Bulletin No: REF059a
Date Issued: 06/08/2009
Reference No: EHR-304/343

## SERVICE BULLETIN REFRIGERATOR

MODEL: SJF65PC-SL/WH, SJF65PSSL, SJF60PC-SL/WH, SJF60PSSL, SJF60PVSL

**SUBJECT:** Change of parts – Lamp and Lamp Socket

## **PRODUCTION CHANGE:**

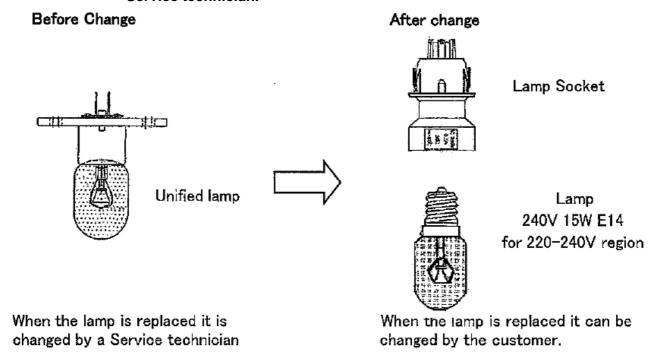
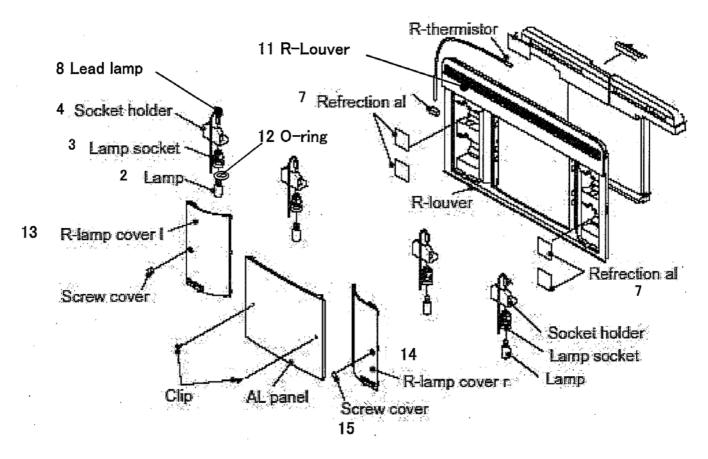
**GENERAL:** The design of the interior lamp has been changed to allow the globe to be

purchased and replaced separately.

Please note that the new and old parts are not interchangeable and care must be taken to ensure the correct part is ordered according to the serial number of the unit. **Customers** can replace the lamps <u>only</u> but the lamp socket will need to be replaced by a Service technician.

**ACTION:** Before ordering a replacement globe, check the serial number of the refrigerator

in Table 1 below to determine the correct part to order.
